ADDENDA: 01

Moore Station Expansion

Project Name: Moore Station Expansion Addendum 01
Addendum Date: August 8, 2022

A251

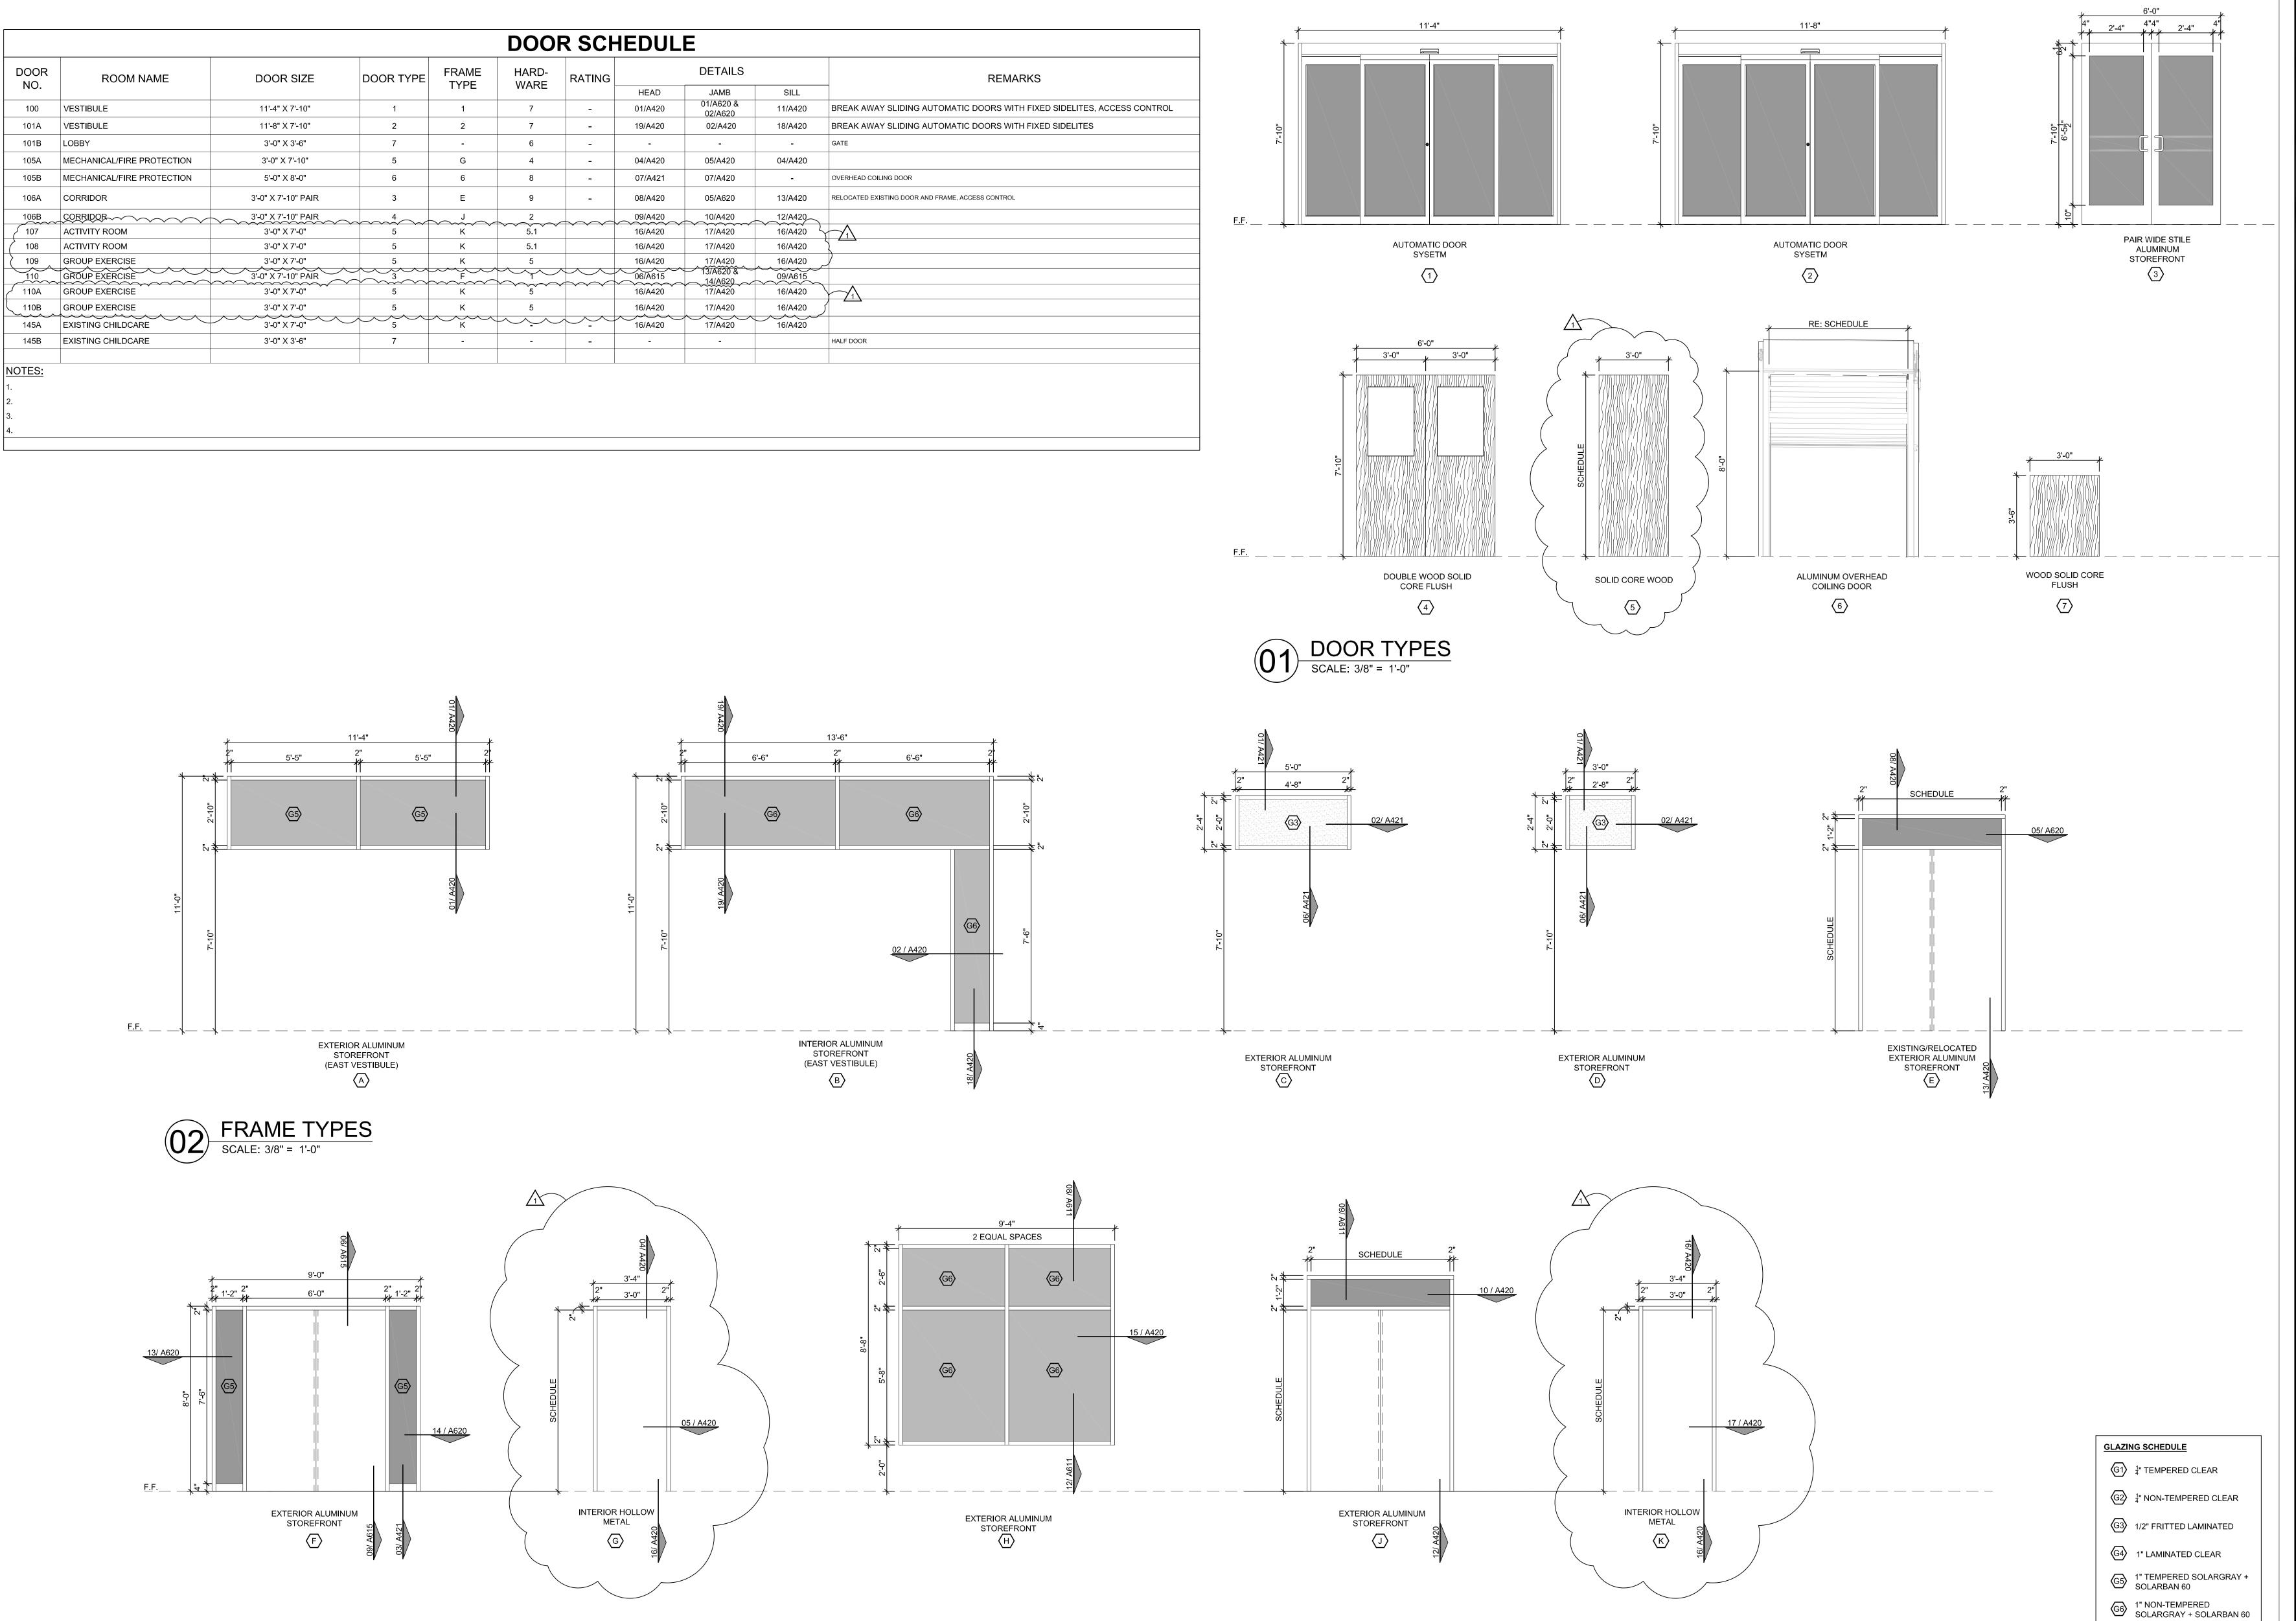
A1.6.8: Refer to Sheet A251 – Remove portion of existing partition.

Scope of work to include patch & prep to match finishes in

surrounding area.

A410

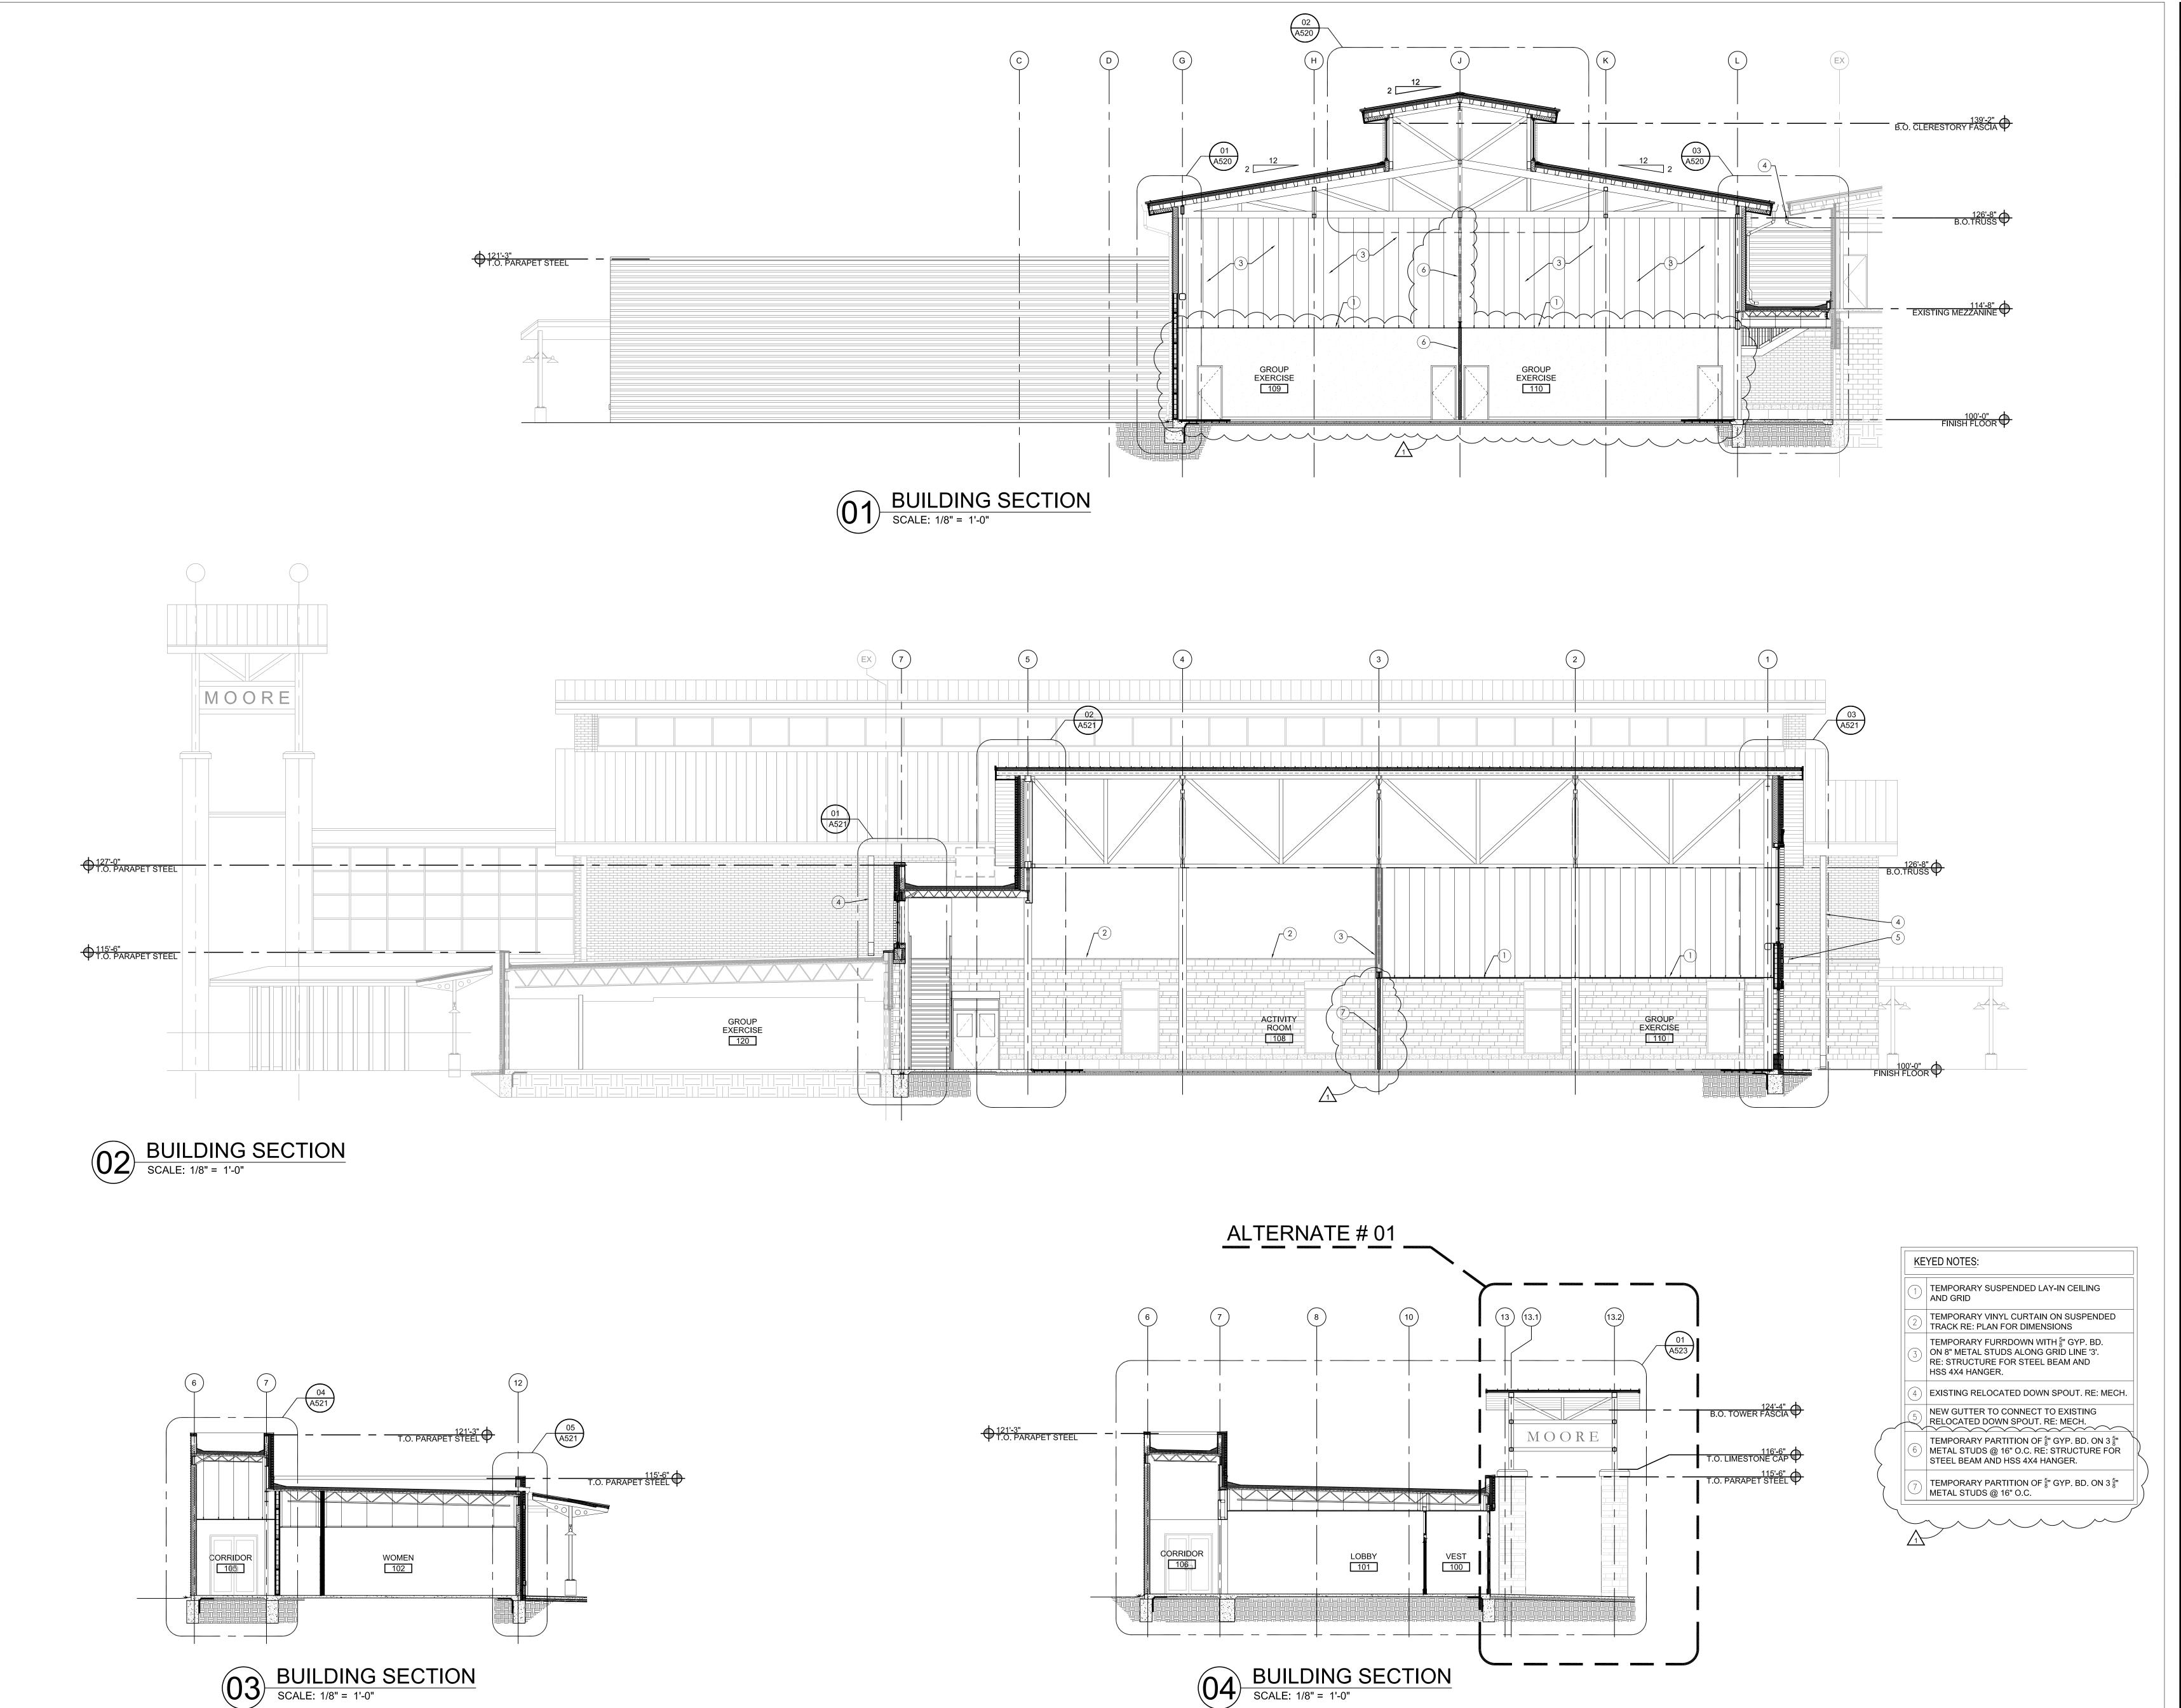
A1.6.9: Refer to Sheet A410 – Add doors 107, 108, 109, 110A, & 110B.

A510

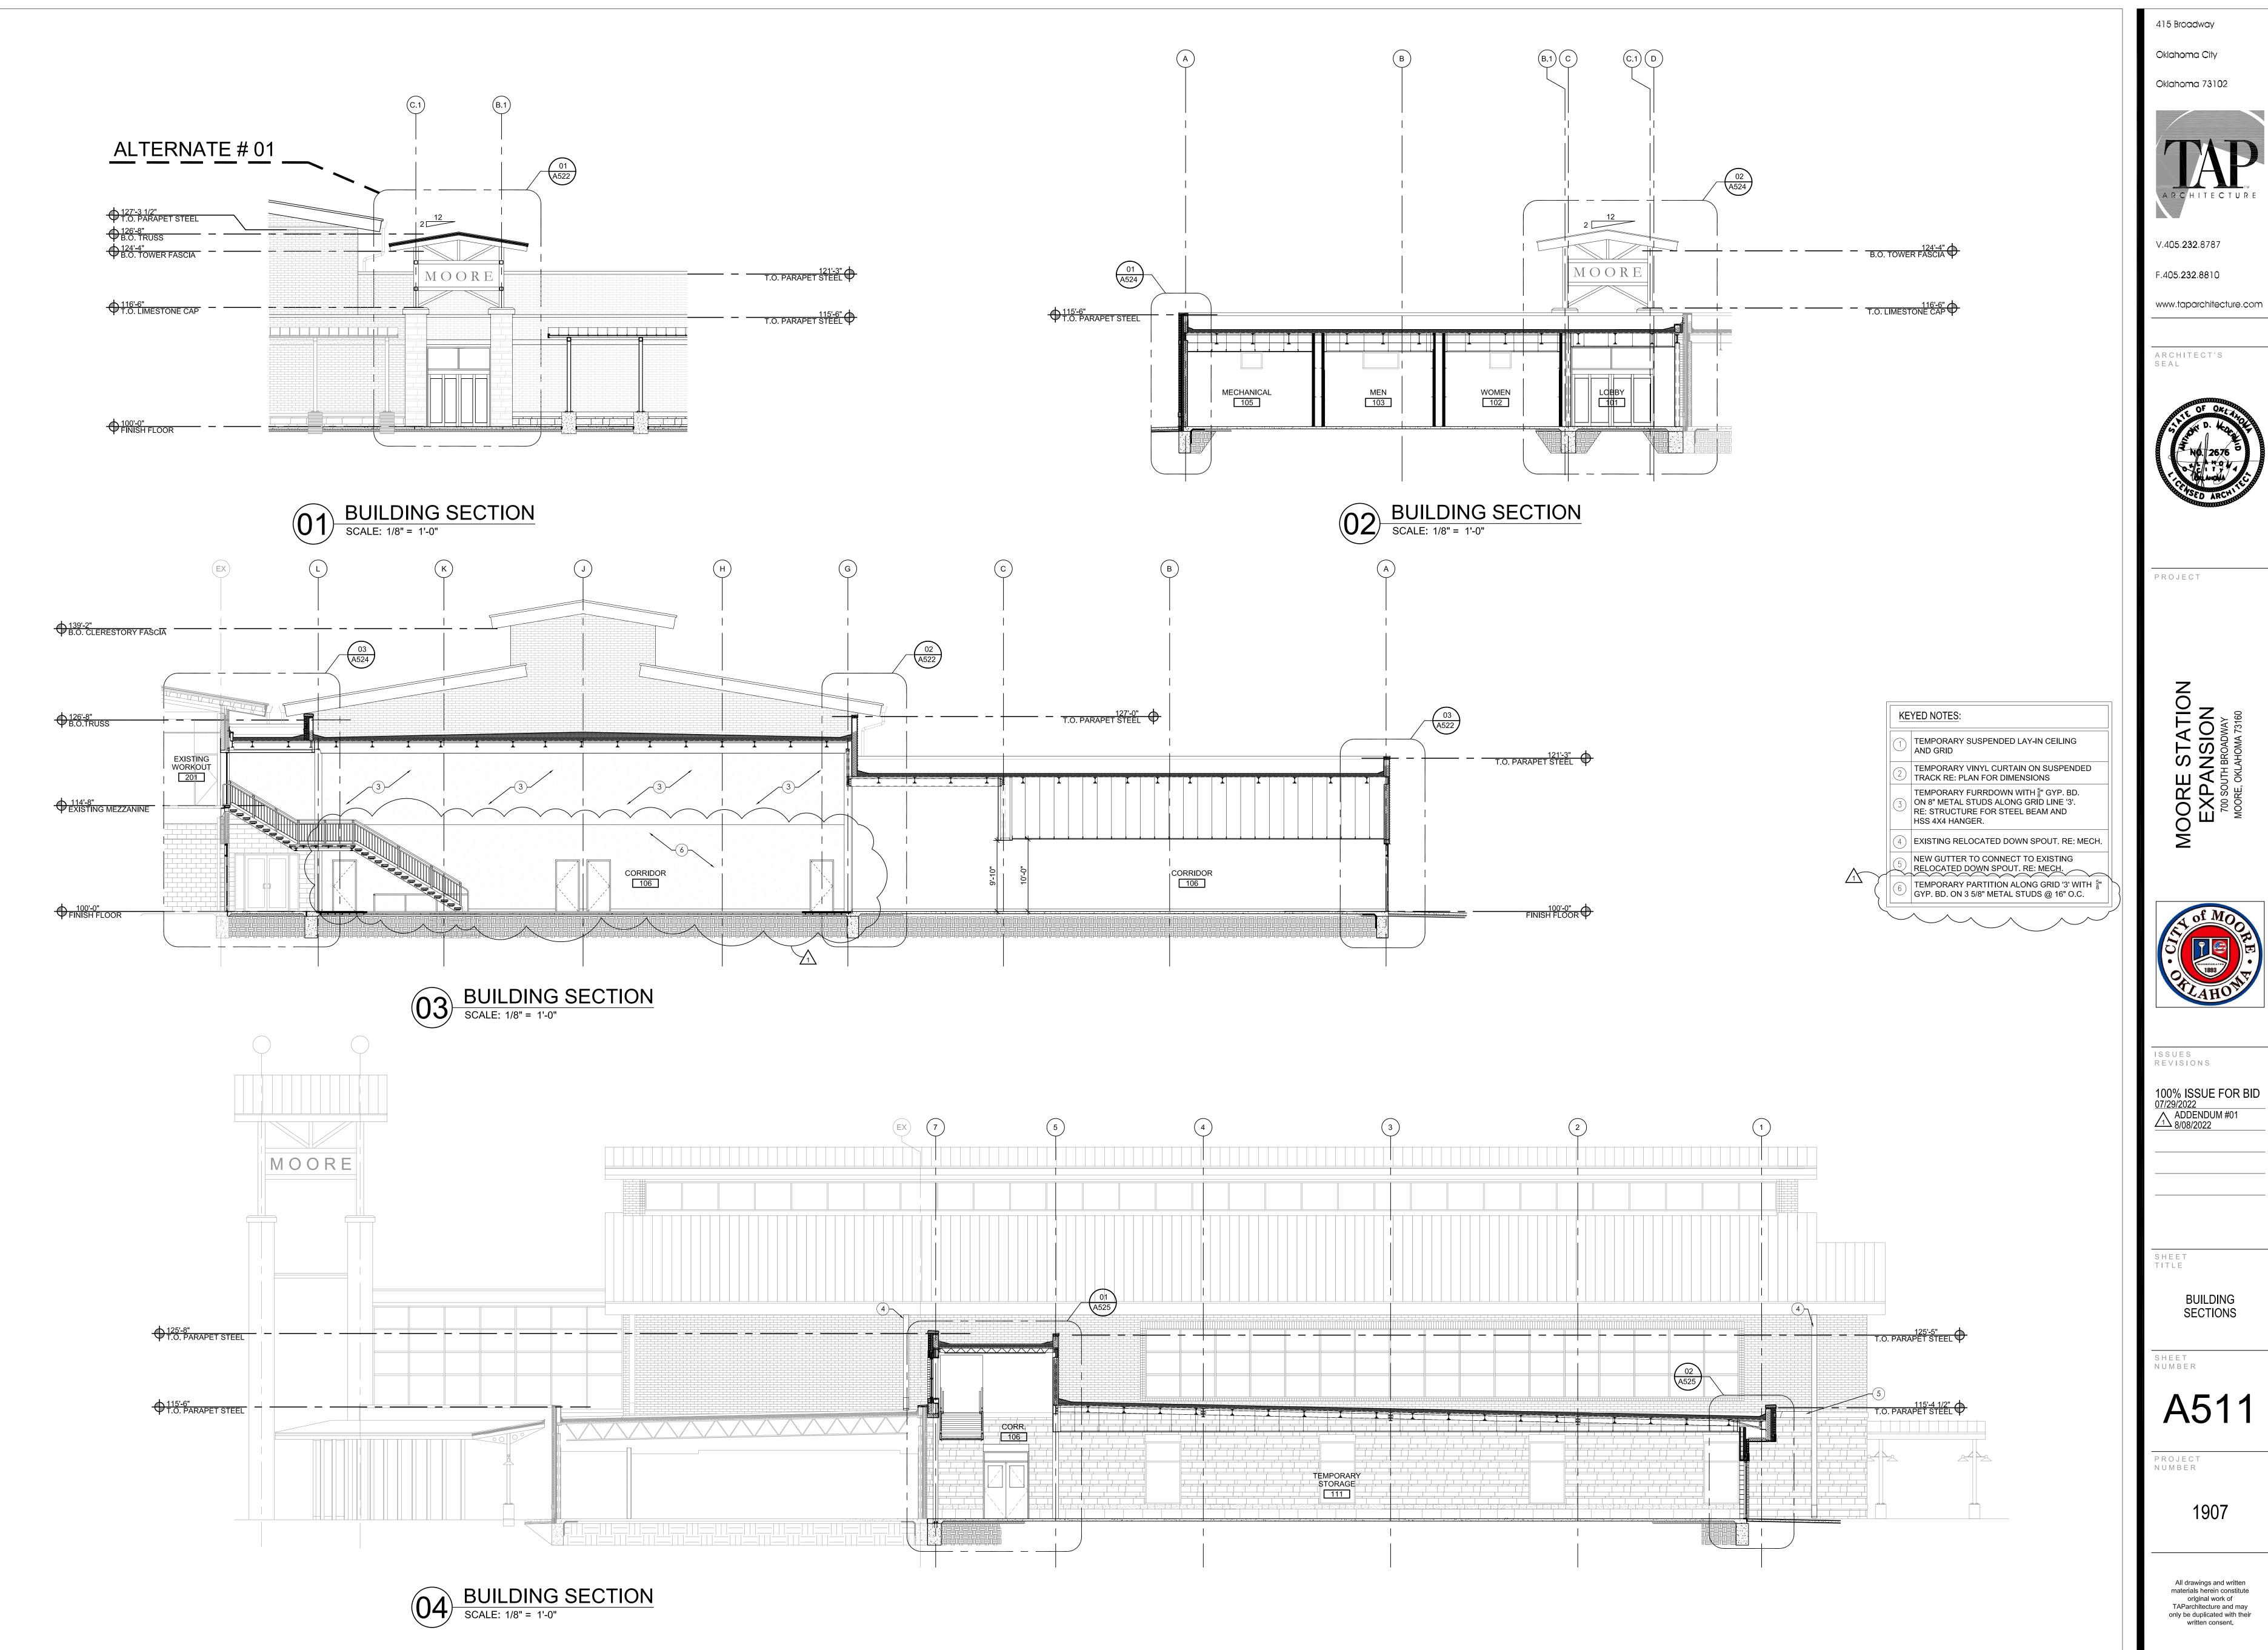
A1.6.10: Refer to Sheet A510 – Add (2) temporary partitions of 5/8"

Gyp. Board on 3 5/8" metal studs @ 16" O.C. (1) partition to

require structure from truss above.
